ASSESSMENT REPORT

WHITE ROCK WIND FARM SECTION 75W MODIFICATION (10_0160 MOD 3) Changes to construction and operation infrastructure and facilities

Figure 2: Proposed modifications

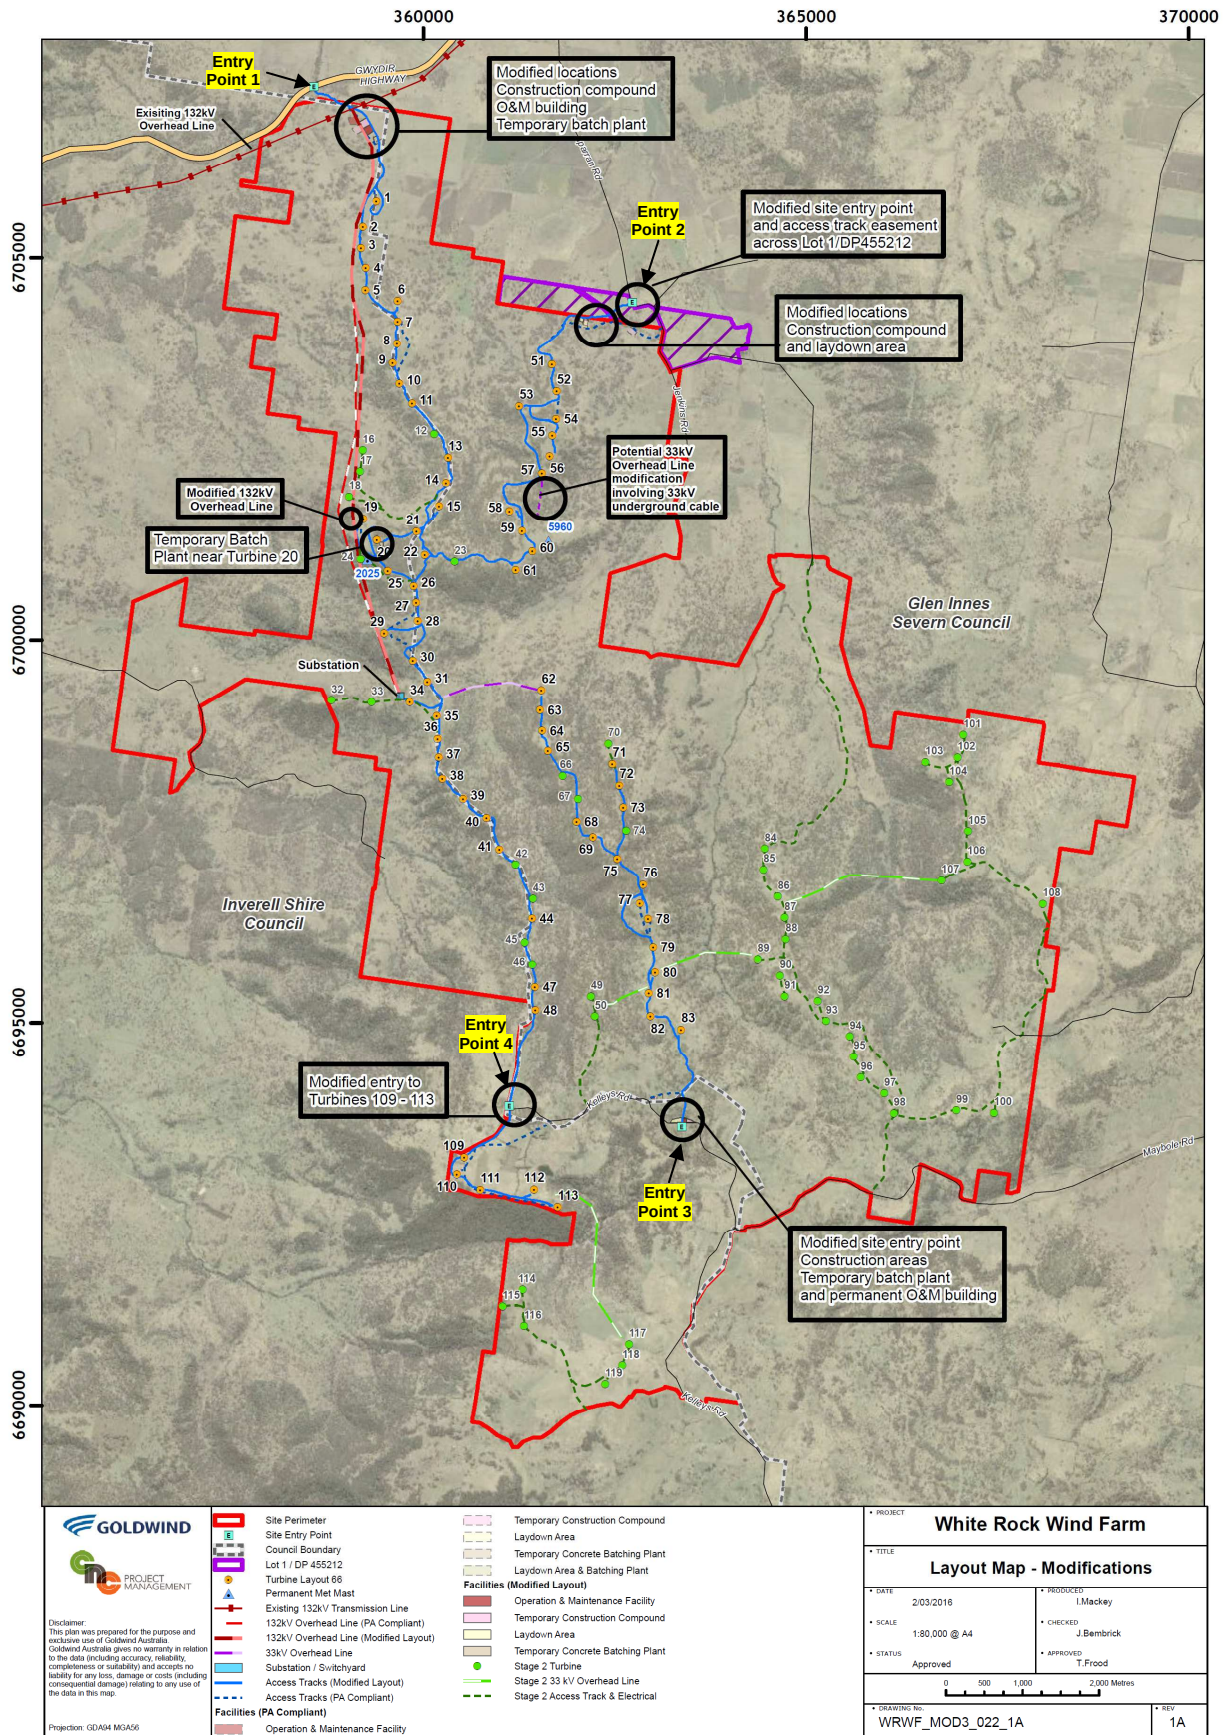
White Rock is proposing to modify the approval for the project (10_0160 MOD 3) (see **Appendix C**). There are two main components to the modification (see **Figure 2**):

In general, the modifications have been proposed to reduce impacts including reduced vegetation clearing and / or to improve constructability. The components and the reasons for modification are presented in **Table 1** and shown in **Figure 2**.

Component	Reason for modification
Construction (temporary) infrastructure	
New construction compound (near Kelleys Road, southern end of the site)	Reduce use of Kelleys Road
New amenities and laydown area (near Kelleys Road, southern end of the site)	Reduce use of Kelleys Road
New temporary concrete batching plants: - near turbine 20 (White Rock Mountain approximately in the centre of the site) - at southern entry	More practical site for delivery to elevated turbine sites, reduced time for concrete pours with less fleet requirements
Operational (permanent) infrastructure	
Relocating the 132 kV transmission line	Avoid significant vegetation
Relocating three site entry points: - Ilparran Road to turbine 51 (entry point 2); - Kelleys Road to turbine 83 (entry point 3); and - Kelleys Road to turbine 109 (entry point 4).	Reduce vegetation impacts Reduce length/distance from residence Move due to landowner preference

Relocating the approved operations and maintenance facility (south of the site)	Avoid construction work conflicts
New operations and maintenance facility at southern entry point at location of construction site office	Provide facility for the southern portion of the wind farm
Relocating some access tracks: - to turbine 1 - to turbines 9 and 10 - to turbine 19 - to turbine 29 - to turbines 28 and 30 - to turbines 53 and 54 - to turbine 79 to 76	Improve constructability Reduce track length Improve constructability / reduce visual impact Improve constructability Improve constructability Improve constructability / reduce visual impact Improve constructability
Change from overhead to underground for the 33 kV cable	Reduce vegetation impact
Collocating a portion of infrastructure for the White Rock Solar Farm within the wind farm infrastructure corridor from a point near turbine 1 / 2 (north of the site) to the wind farm substation (south of the site).	Utilise an existing corridor for the purposes of receiving and exporting electricity from the proposed White Rock solar farm (SSD 7487, subject to that project's approval).

Figure 3:
Modified site
entry locations

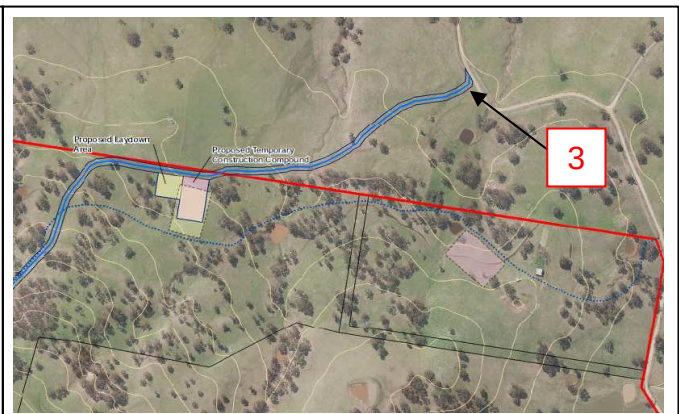
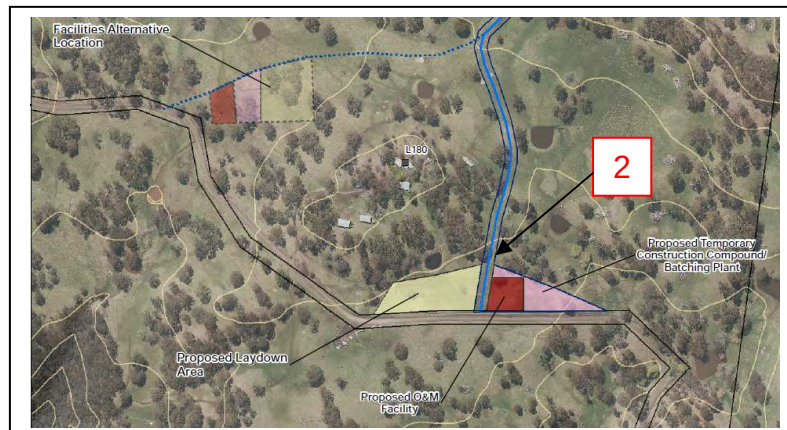
The changes to site entry points and the reasons for the changes are shown in **Table 2** and **Figures 2** and **3**.

Component		Reason for modification
Ilparran Road to turbine 51	entry point 2	Safer access point Reduced vegetation impacts Reduces track length by 500 m Uses 600 m less of Ilparran Road
Kelleys Road to turbine 83	entry point 3	Request of the landowner Reduces track length by 60 m
Kelleys Road to turbine 109	entry point 4	Moves it further away (500 m west of the approved location) from the nearest residence to avoid disrupting farming activities Reduces track length by 400 m

These changes are considered minor and do not change the transport impacts of the project because the same roads are impacted (albeit in slightly different locations) and the changes improve safety and / or reduce travel on Council roads.

Inverell Shire Council requested involvement in the dilapidation assessment reporting. The Department notes that Inverell Shire Council would be involved in the road dilapidation report where applicable as the relevant roads authority. This is required in the existing approval and therefore does not require changes to the approval.

Figure 1 – Schematic arrangement of WRSF cable within WRWF cabling corridor

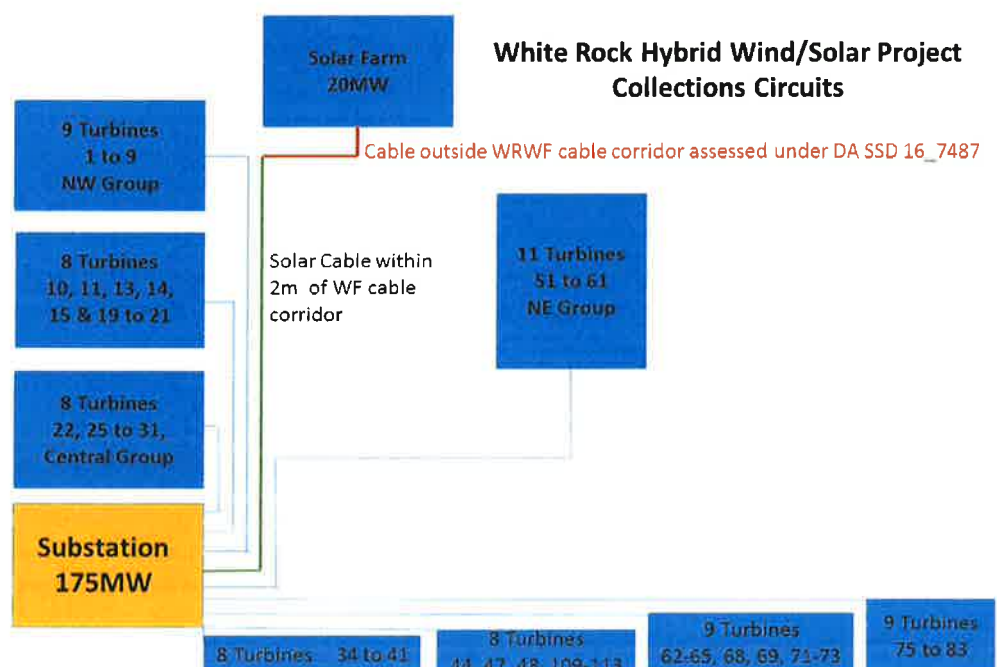
The shared WRWF components to be used by WRSF to connect to the Grid have been assessed for the WRWF Project Approval and, their use for WRSF, does not contribute any significant additional impacts on the environment. The placement of the 33kV solar cable where it is within the WRWF footprint will be within 2m of WRWF cabling. At locations closer to the Solar Farm where it is outside the WRWF footprint, the cable's impact has been assessed under DA SSD 16_7487 for WRSF (Fig 1).

Figure 1 shows multiple cable circuits as there are limits on the number of turbines that can be feasibly connected via a single cable. Eight (8) collector circuits are proposed for WRWF Stage 1. The Solar Farm adds an additional cable that will join a WRWF cabling corridor. Multiple cables are aligned side by side within corridors. The cable route from the Solar Farm to a point near Turbine 1 or 2 has been assessed in the WRSF EIS. The solar farm cable then aligns with a single cable from the NW group of WRWF turbines, involving a corridor of two cables. From Turbine 10, the corridor involves three cables and eventually near the substation, a total of nine cables (including the solar farm cable) are aligned side by side approaching the substation. The schematic in Figure 1 shows the 33kV cable circuits that are proposed for WRWF and WRSF and schematic relations. The Solar Farm cable is within 2m of WRWF cable and within the cable and buffers assessed for WRWF.

After review of options for the design of the cabling installation, and particularly spacing requirements for the WRWF and WRSF 33kV cables, I am able to advise that the additional cable is able to be installed within the WRWF cabling corridor without any additional impacts beyond those assessed for the White Rock Wind Farm Project Approval (MP10_160).
